Re: R15-22 (Rulemaking Water)  
Public Water Supplies: Proposed Amendments to 35 Ill Adm. Code Parts 601, 602 & 603  
Submission of Comments / Testimony for Second Hearing to be held August 17, 2015

**PUBLIC WATER SUPPLIES: PROPOSED AMENDMENTS TO 35 ILL. ADM. CODE PARTS 601, 602, AND 603.**

COMMENTS SUBMITTED BY: Roger K. Mensing, P.E.  
As an individual.  
201 Covered Bridge Lane  
Belleville, IL 62221  
Work Ph. 618-327-8841

**EXHIBIT A**

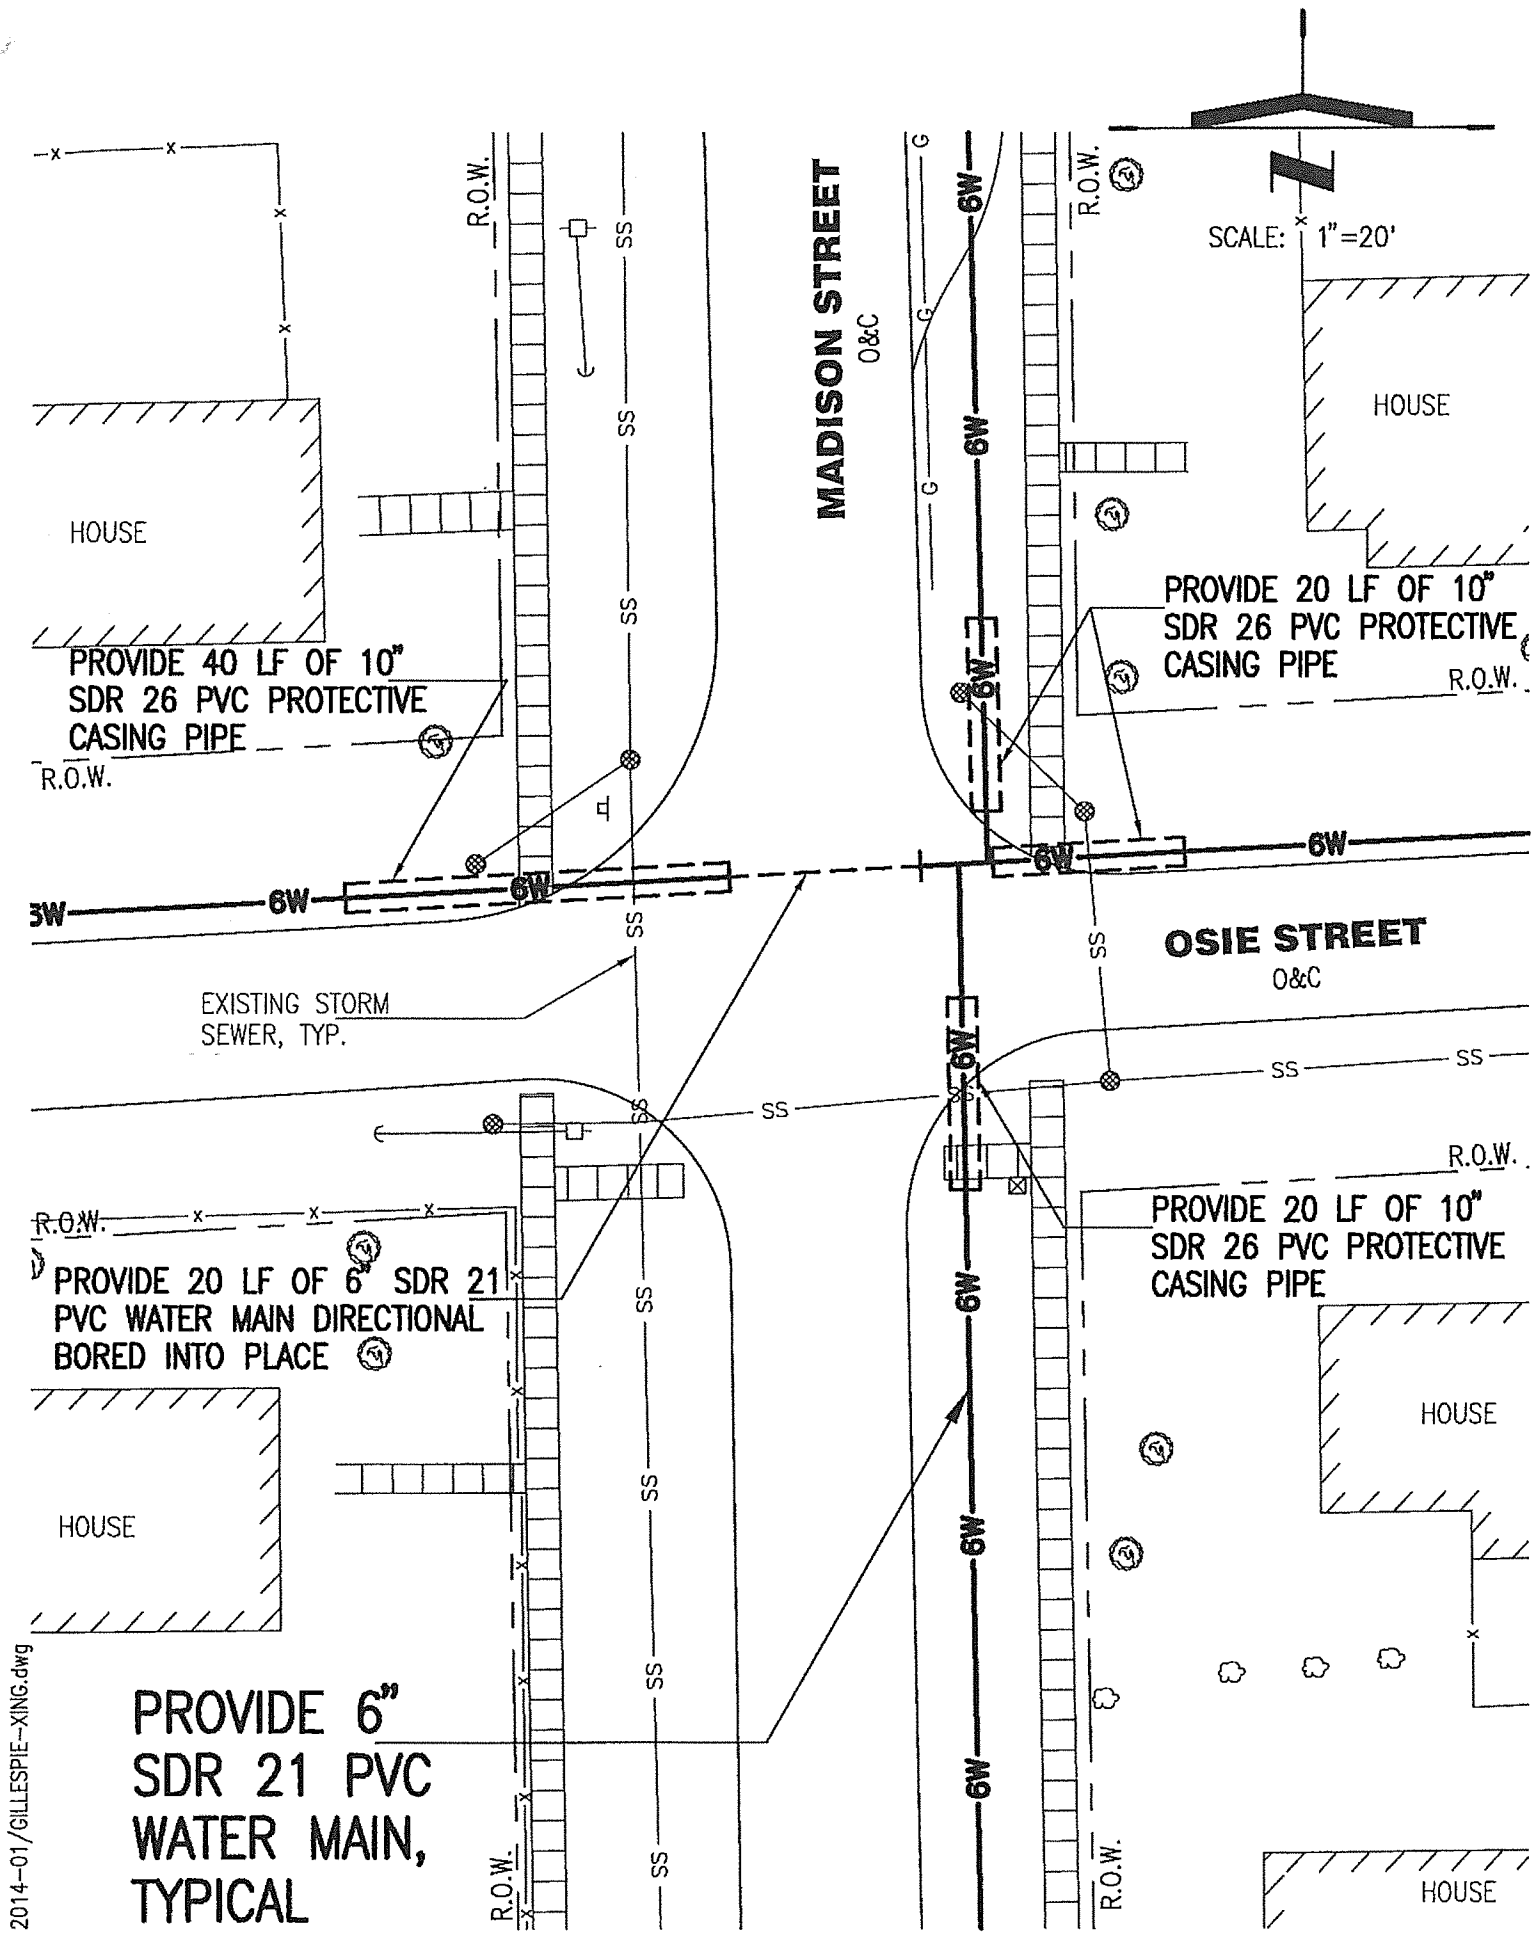
For installations where a new water main crosses below a storm sewer with 18" of separation, the Agency has required that a casing be installed over the water main if the storm sewer is not constructed of water main pipe. This installation will cause maintenance issues for water systems in the future if repairs ever need to be performed. While the regulations call for the end of the casings to be sealed, any current product on the market today cannot be considered to be "bottle tight" for the lifespan of the water main. I have personally witnessed that these casings will hold stagnant water around the water main. The rules do not allow water mains to be installed within 18" of a storm sewer at all, yet the encased water main is surrounded by stagnant water of unknown bacteriological quality.

4. The cost is a significant burden to local communities. Current costs from recent bids indicate that it costs approximately \$50 per foot to install protective casings on 6" water lines. Costs would of course be higher for larger diameter pipe. In the attached example, (Exhibit A), a local community would have to expend approximately \$3,200 to install protective casing for just one intersection. This community has highly deteriorated cast iron water mains, and this money would be much better spent in installing more new water mains for their residents.
